**Well Name:** HANCOCK FEDERAL

**US Well Number:** 3004506425

### Subsequent Report

**Type of Action:** Plug and Abandonment

Original Hole, HANCOCK FEDERAL 3 [VERTICAL]

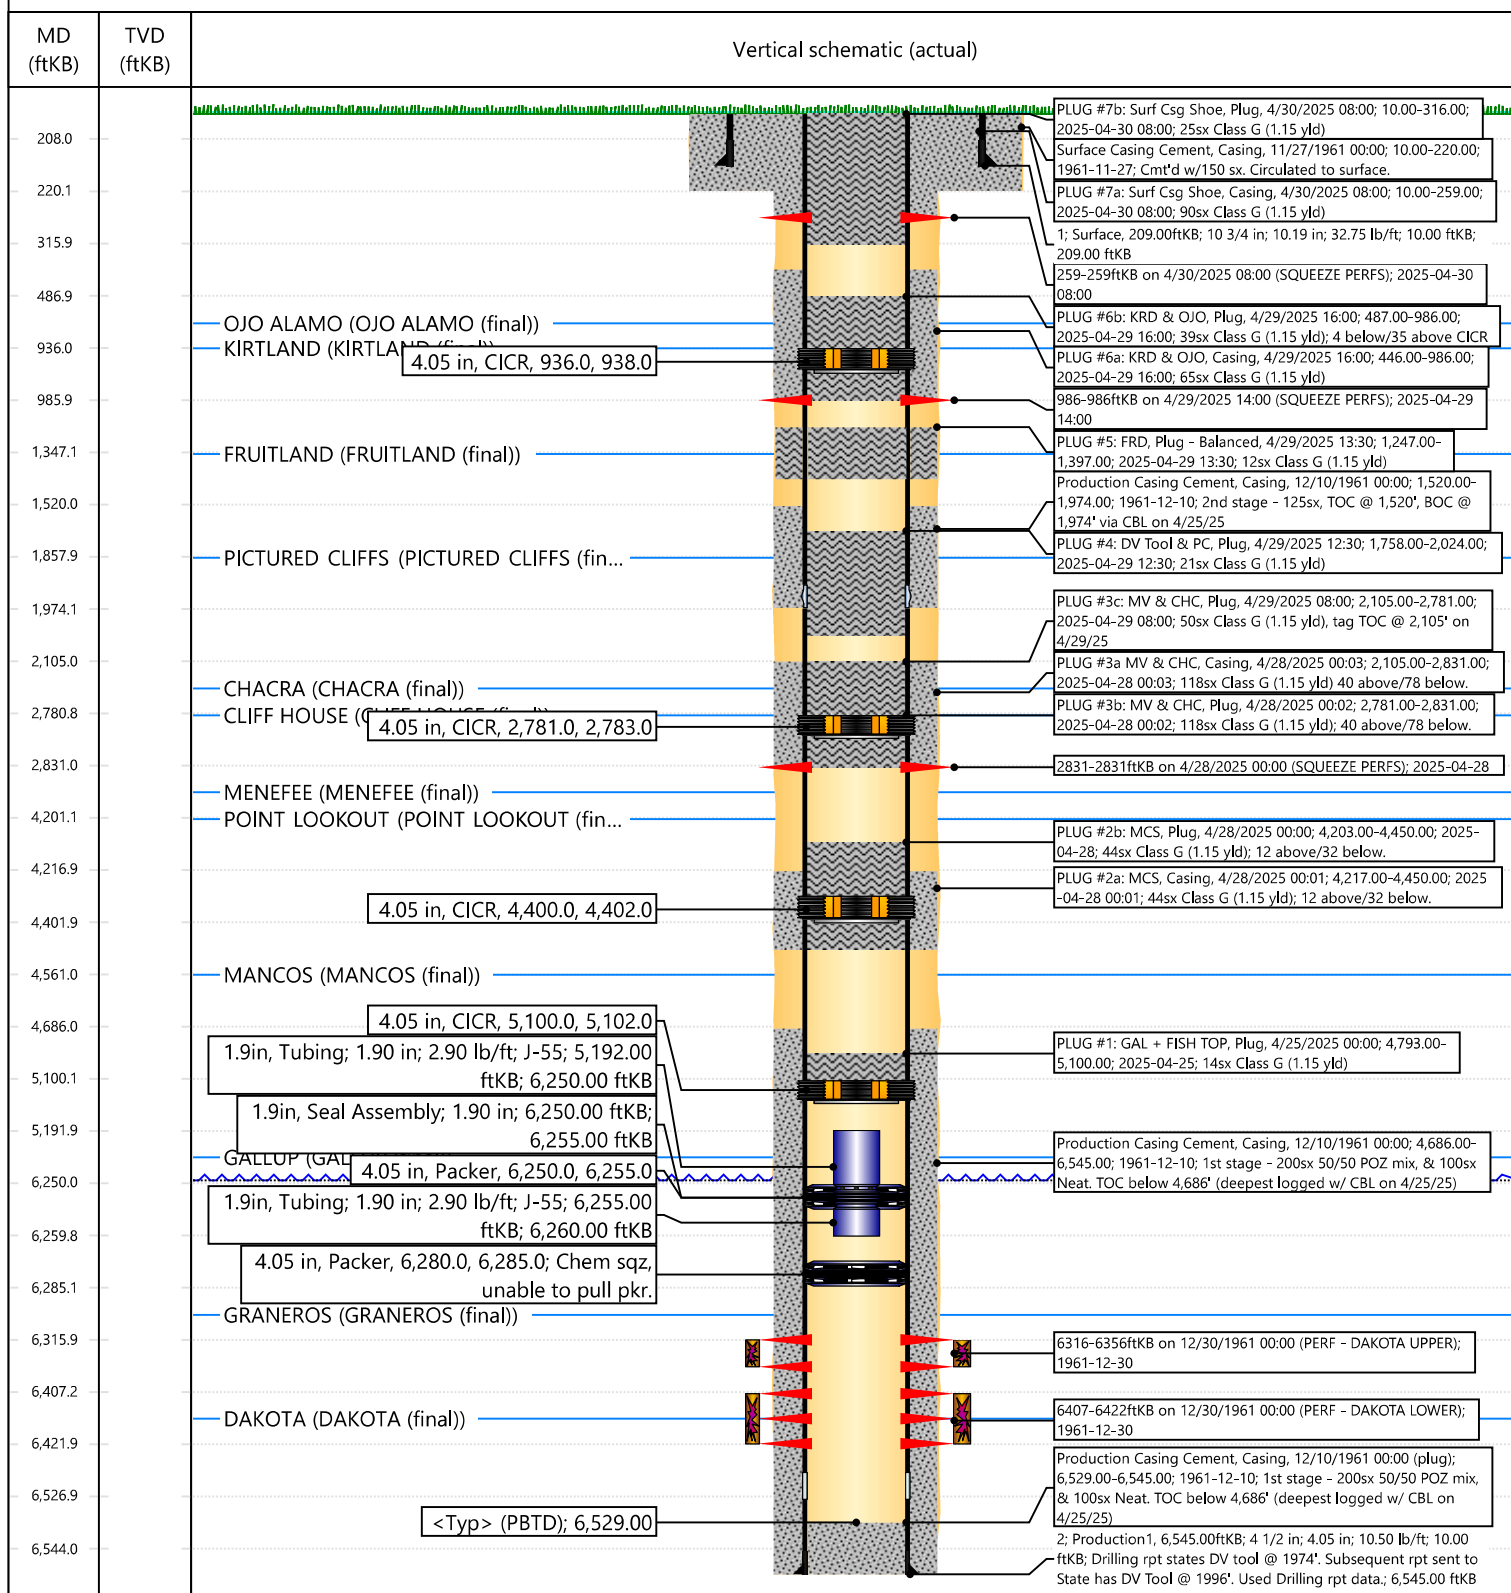
Per our conversation, we will make the below changes to the procedure due to a likely casing failure, fill, and poor tubing conditions severely hampering our ability to retrieve any more of the fish and get deeper into the well.

- Set a CICR at 5,100'. Attempt to pump the equivalent volume of cement down to the perfs (3.7 bbls down tubing).
  - We will then sting out and pump 150' of cement on top of the CICR.
  - WOC and tag. Attempt to pressure test and run CBL.
- If able to pressure test, we will continue forward with the prior approved procedure from this point.

NMOCD approves below –

The BLM approves of the change to procedure.
